**Re: Joint Permit Application Number 14-0343
Response to December 12, 2014 Email and December 17, 2014 follow-up email
James River Water Supply Project, James River Water Authority**

1. Environmental Impact Summary Sheet Nos. 1 and 2 dated 12/19/2014
2. JRWA Overall Map Indicating Demand Centers and Return Flows to the James River dated December 19, 2014

JRWA RAW WATER INTAKE, PUMP STATION AND FORCE MAIN
 FLUVAINA COUNTY, VIRGINIA
 ENVIRONMENTAL IMPACT SUMMARY

JRWA RAW WATER INTAKE, PUMP STATION AND FORCE MAIN
FLUVANNA COUNTY, VIRGINIA
ENVIRONMENTAL IMPACT SUMMARY

JOB NO.
34967
 SHEET NO.
2 OF 2

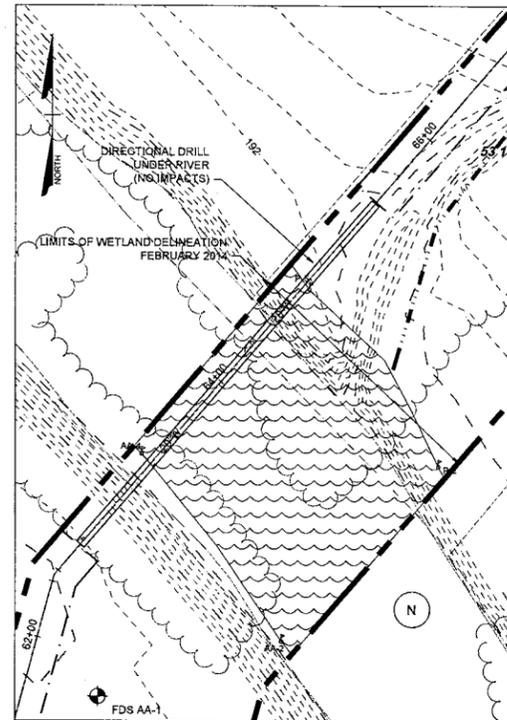
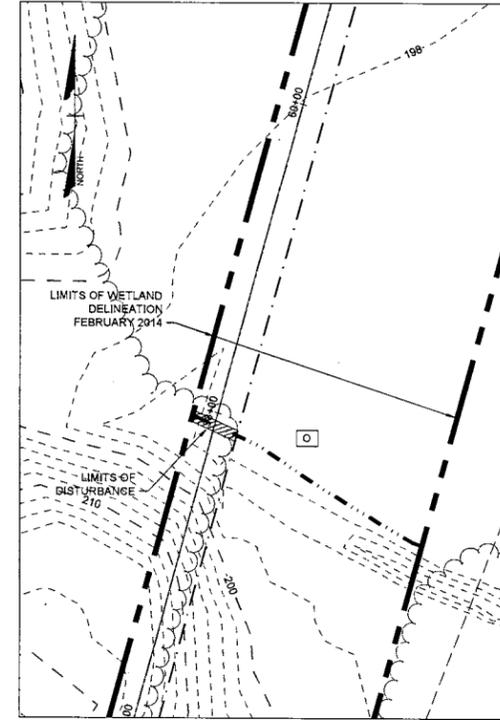
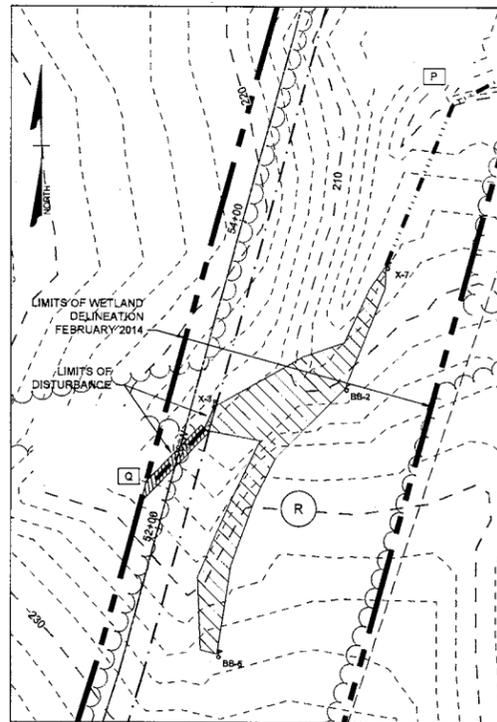
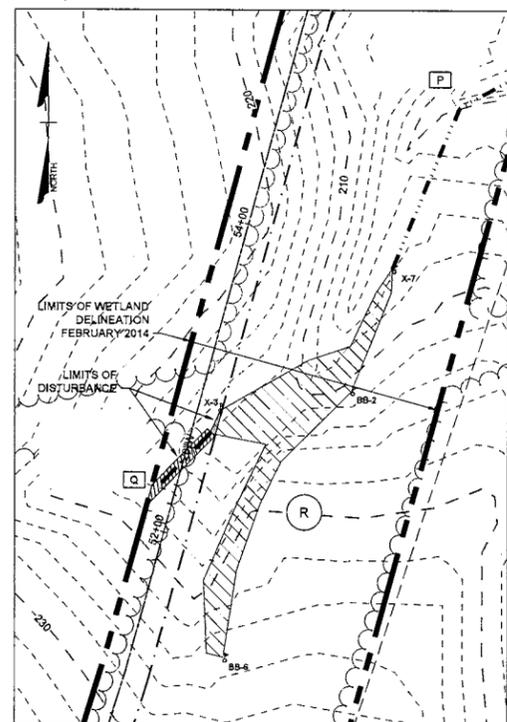
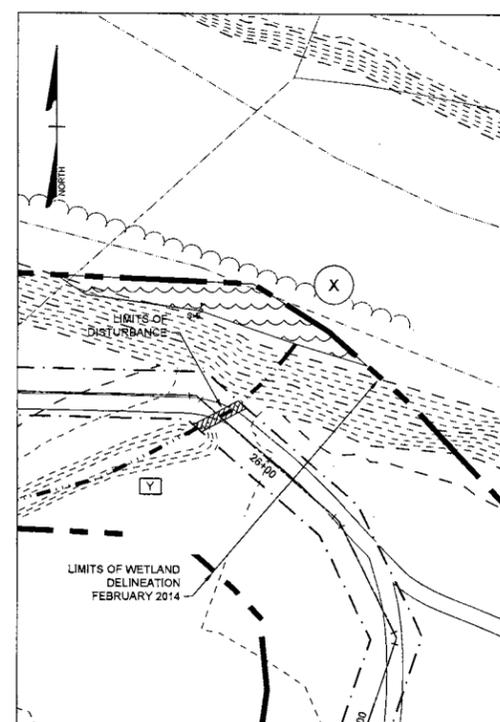
c. *Consistent labeling of the surface waters and impact areas identified on the plan view.*

Labeling has been revised accordingly. Please see attached Sheet No. 1 and 2 dated 12/19/2014.

AA - JAMES RIVER RAW WATER INTAKE IMPACT AREA DETAIL

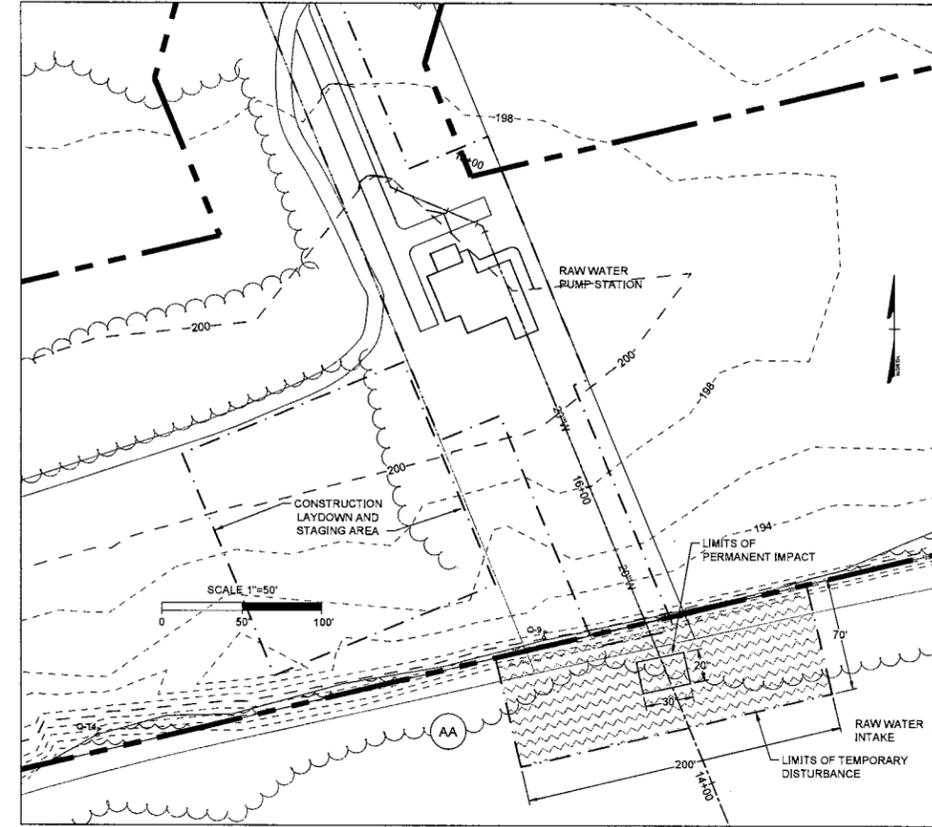
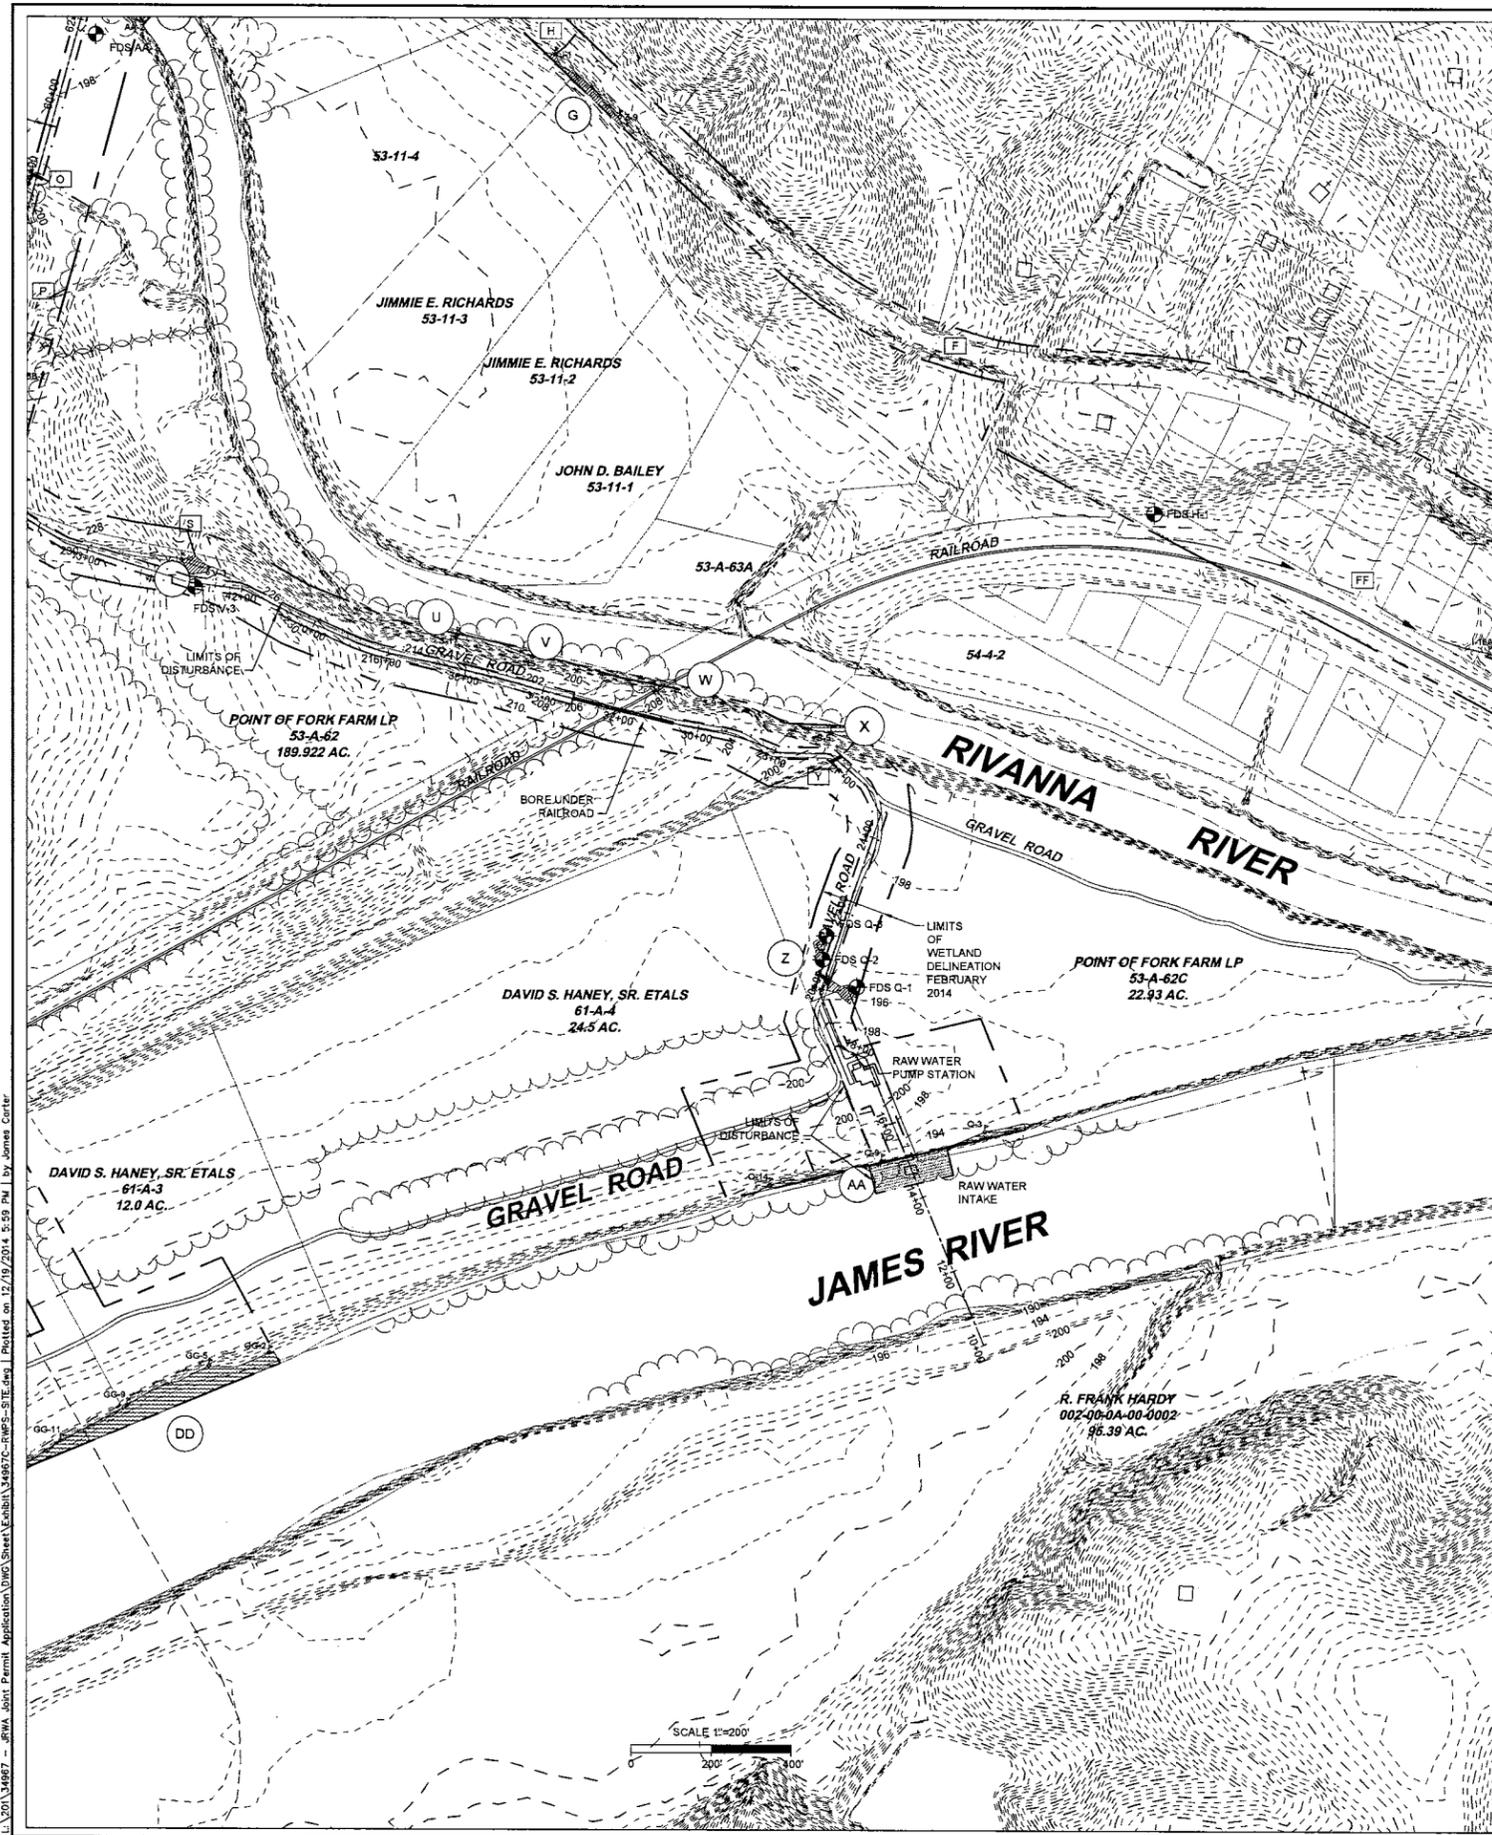
a. *The extent of the proposed impact area depicted on the plan view.*

b. *The linear feet of impact to the James River that is associated with the proposed intake.*

d. *A legend on the plan view that identifies what meaning of each symbol used.*

The extent of the proposed impact area for the river has been revised on the attached Sheet No. 1 of 2 dated 12/19/2014. The limits of the **temporary impacts for the intake structure installation are 0.32 acres** (200' by 70' or 14,000 SF) and the limits of the **permanent impact for the intake structure are 0.014 acres** (30' by 20' or 600 SF).

The linear feet of impact to the James River is **200 LF of temporary surface water impact and 30 LF of permanent surface water impact.**

Legend has been revised accordingly. Please see attached Sheet No. 1 of 2 dated 12/19/2014.
